# Proposed Changes to Design and Construction Standards Manual Section 700

September 2019

Marc Aveni Environmental Services

Example of a swale

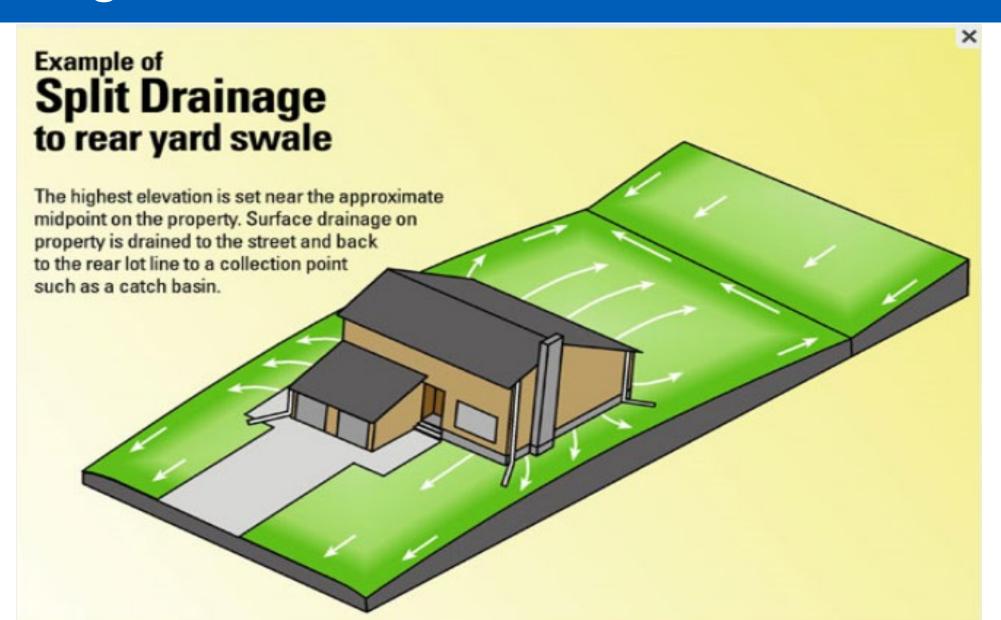
- 5) Approved lot grading plans adversely altered because of builder changes to finished floor/footing elevation as well as other deviations from approved plans
- 6) Swales provided with less than 2 percent slope or nearly flat longitudinal slopes (water does not flow)
- 7) Inadequate positive drainage away from the foundation and nearby home openings

Drop inlet handling large flows close to basement entrance

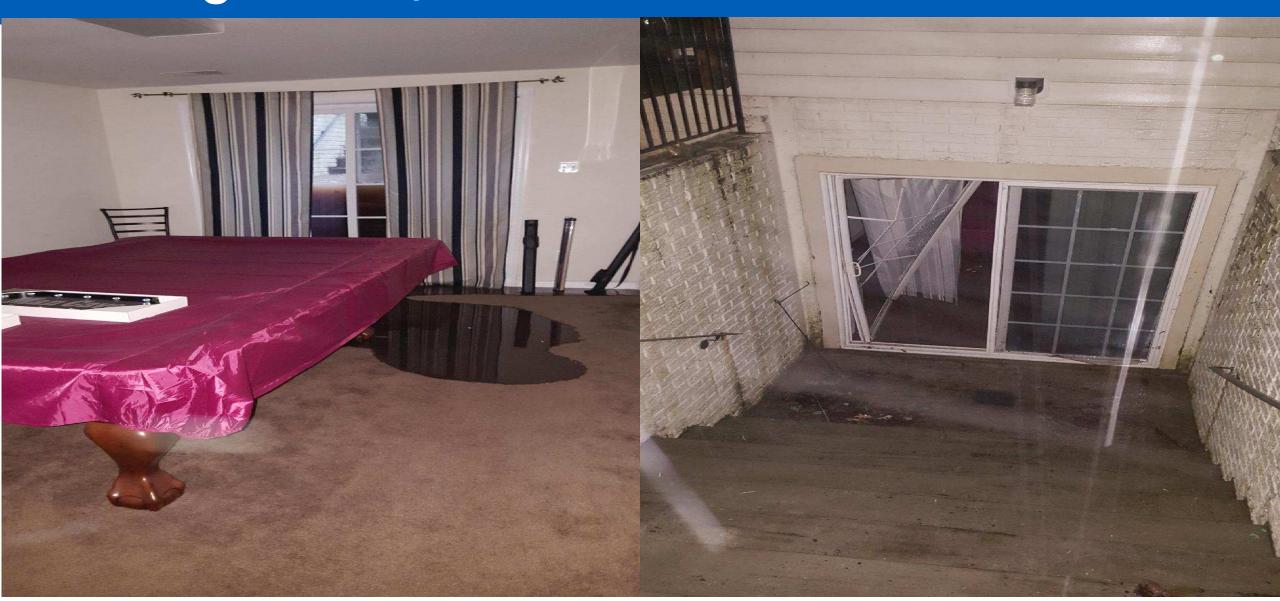
Flooded basement
